AMENDMENTS TO THE DRAWINGS

REMARKS

I hereby certify that this correspondence, an Amendment under 37 C.F.R. § 1.111, is being deposited with the United States Postal Service, as First Class Mail, postage prepaid, in an envelope addressed to

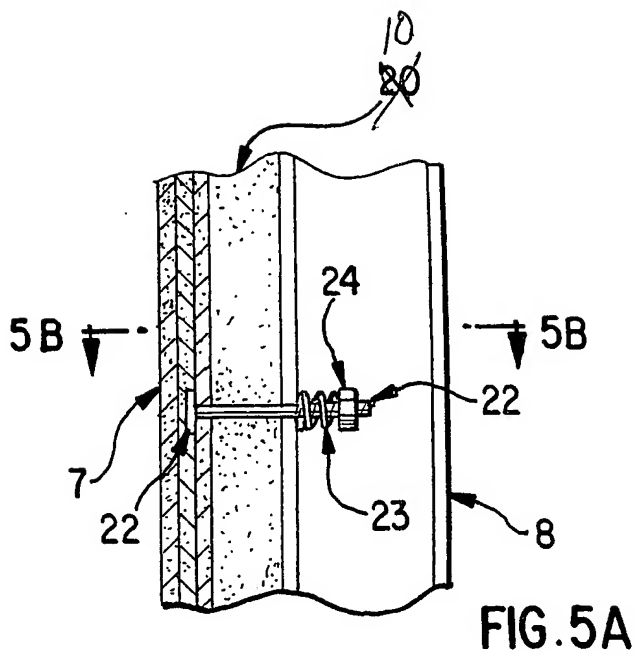
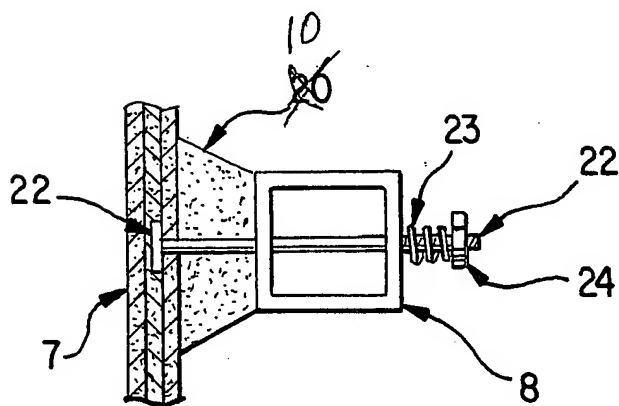
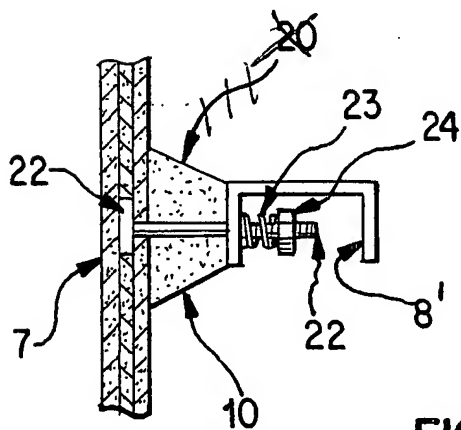
Additionally, the same parts had been designated in the specification by different reference numerals. More specifically, the elastomer has been identified, for example, in Figure 5C by reference numeral (10) as also by reference numeral (20). To assure uniformity, Figures 5A, 5B and 5C are amended to provide consistency. Approval of these changes is respectfully requested as no new matter is involved, and it is further requested that the Replacement Sheets be made a part of the record of the above-identified application.

FIG. 6B

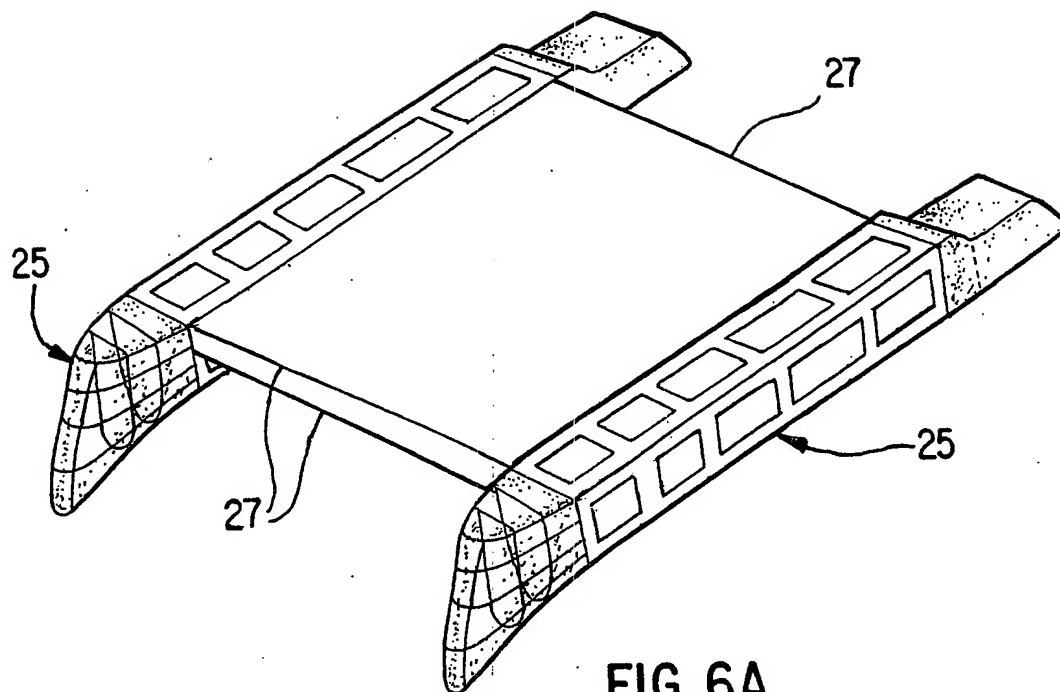
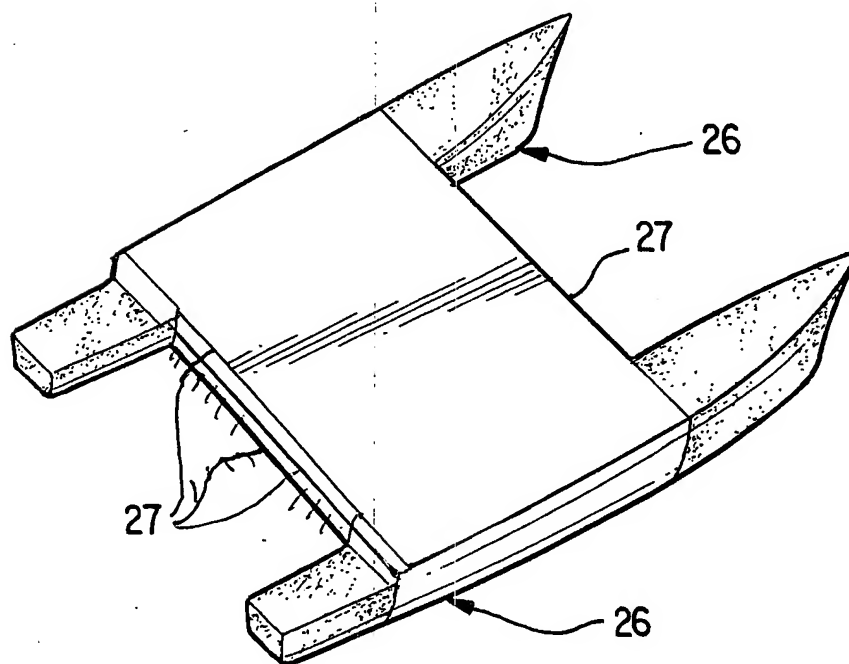
Finally, Figure 6B is also changed to provide uniformity between Figures 6A and 6B of the thickness of the connection cross structure which is made of stiffened steel plating as used in conventional ship design (see page 11, lines 1-12 of the original disclosure). There is no difference between these two figures insofar as this part is concerned.
